PERRY - UNIT 1

DISCUSSION OF CHANGES  
CTS: 3.3.2 - ISOLATION ACTUATION INSTRUMENTATION

PY-CEI/NRR-1951L  
Attachment 2  
Page 10

**Summary of Perry Nuclear Power Plant  
Totally and Partially Relocated Technical Specifications**

FIGURE 3.4.1.1-1

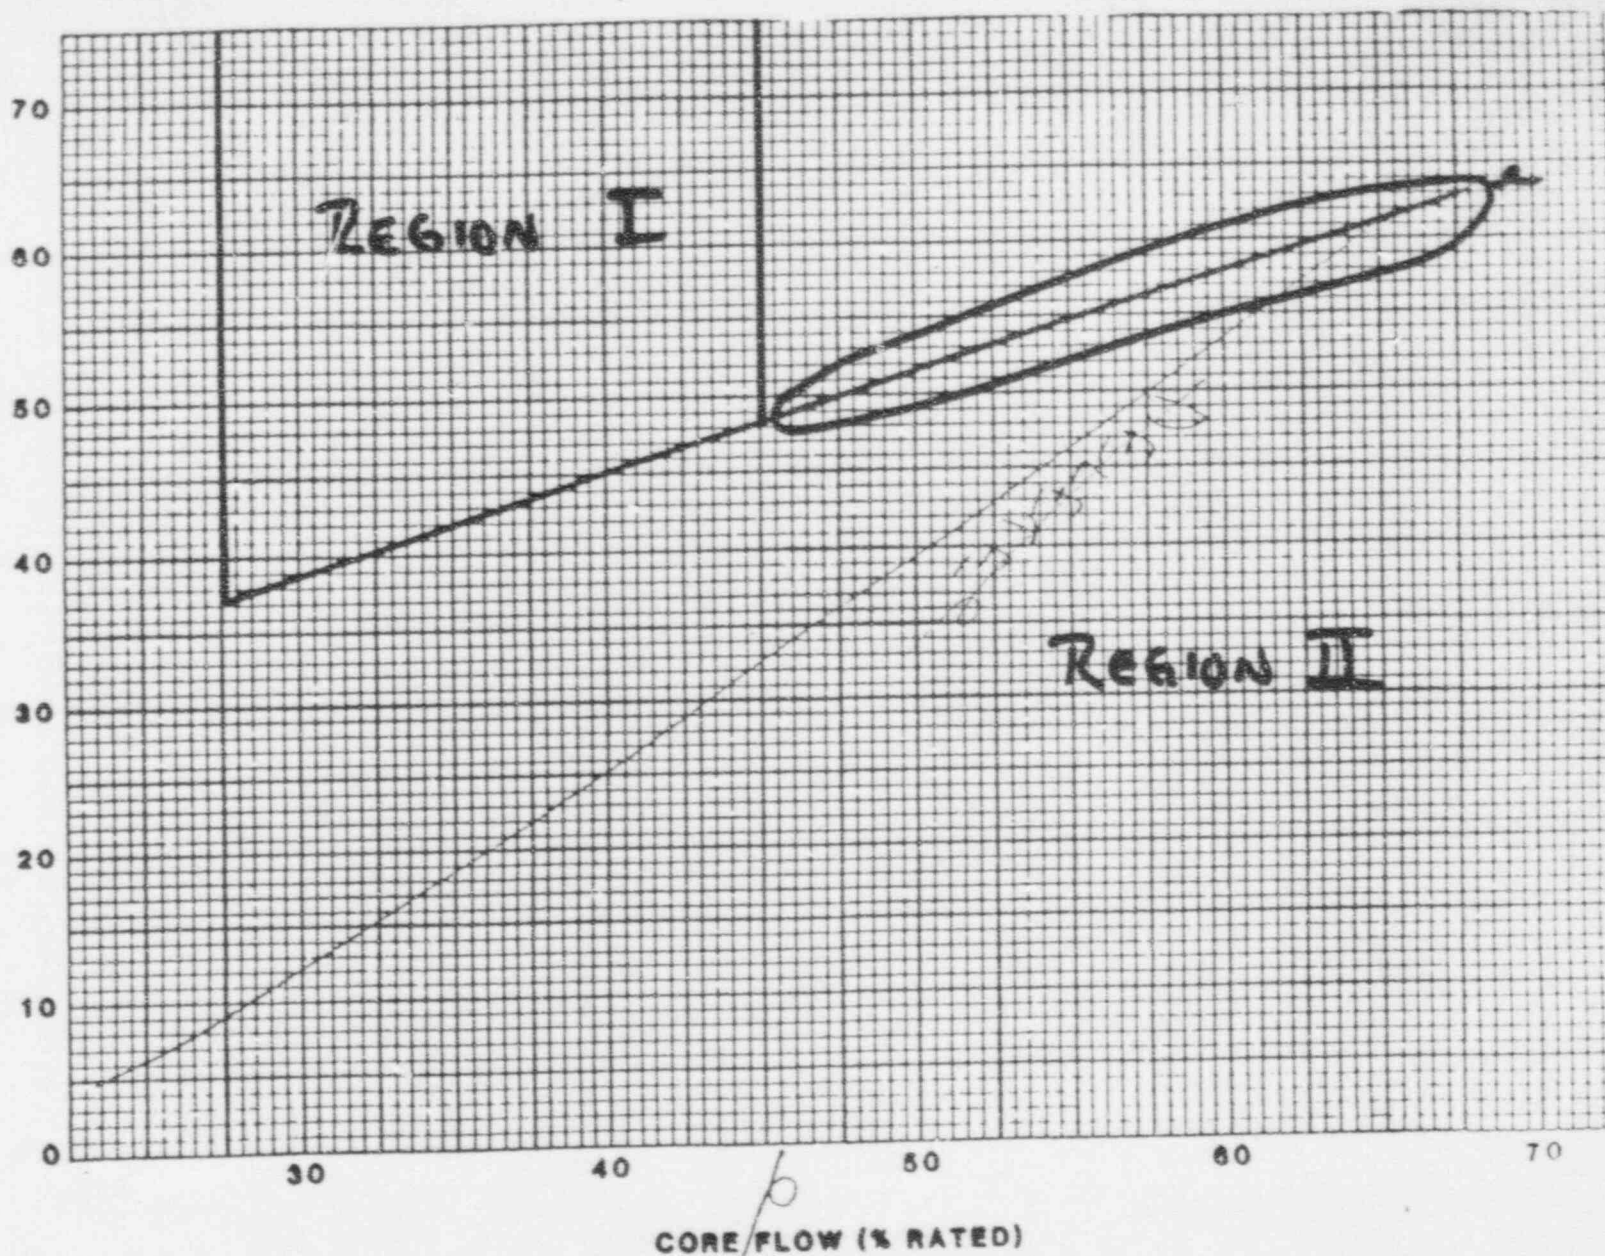
3.4.1.1 The reactor coolant system recirculation loop(s) shall be in operation with the total core flow greater than or equal to 45% of rated core flow, or THERMAL POWER less than or equal to the limit specified in Figure 3.4.1.1-1 and either:

- A.12 The current LCO description of the allowed region of operation, i.e., "... with the total core flow greater than or equal to 45% of rated core flow, or THERMAL POWER less than or equal to the limit specified in Figure 3.4.1.1-1 ..." is now graphically represented on ITS Figure 3.4.1-1 as Region II. Since these regions are equivalent, the proposed change is deemed to be administrative.
